Access Compliance Report

Public Rights-of-Way

(Curb Ramps)

Intersection ID: 9579	Main Street: BANCROFT_ST	Cross Street: FRANKLIN_AV	Location: W
ADA ID: 0E6F58E7B272	Ramp Type: Directional1	Initial Pass/Fail: Fail	Overall Compliance: No
		Severity Score: 1.25

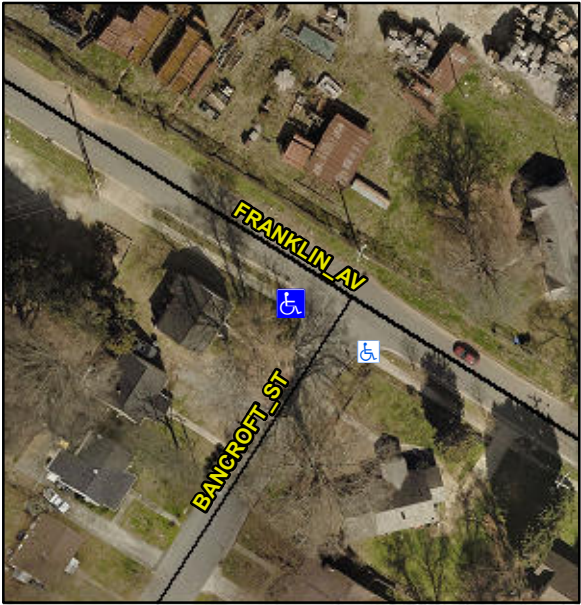
Codes/Mitigation Info/Possible Solution		Field Measurements/Component Compliance			
	Possible Solutions:				
	Remove & Replace Entire Ramp.				
	Surveyor Notes:				
	N/A				
	PROW/ADA:				
	R304.5.3				
	Street 1 Name	BANCROFT ST			
	Stop Condition-Street 1	StopSign			
	Street 2 Name	N/A			
	Stop Condition-Street 2	N/A			
	Total Cost:	\$ 1600.00			
Compliance	Description	Data	Compliance	Description	Data
N/A	Ramp Length (in)	120.5	N/A	Grade Break?	N/A
Yes	Ramp Width (in)	57.0	N/A	Grade Break Slope (%)	0.0
Yes	Ramp Slope (%)	5.5	N/A	Grade Break XSlope (%)	0.0
No	Ramp XSlope (%)	2.4			
N/A	Flare Type LT	N/A	N/A	Flare Type RT	N/A
N/A	Flare Slope LT (%)	N/A	N/A	Flare Slope RT (%)	0.0
N/A	Flare Traversable LT?	N/A	N/A	Flare Traversable RT?	N/A
N/A	Landing Length (in)	0.0	N/A	DWS Provided?	N/A
N/A	Landing Width (in)	0.0	N/A	DWS Contrast?	N/A
N/A	Landing Slope (%)	0.0	N/A	DWS Length (in)	N/A
N/A	Landing X Slope (%)	0.0	N/A	DWS Full Width?	N/A
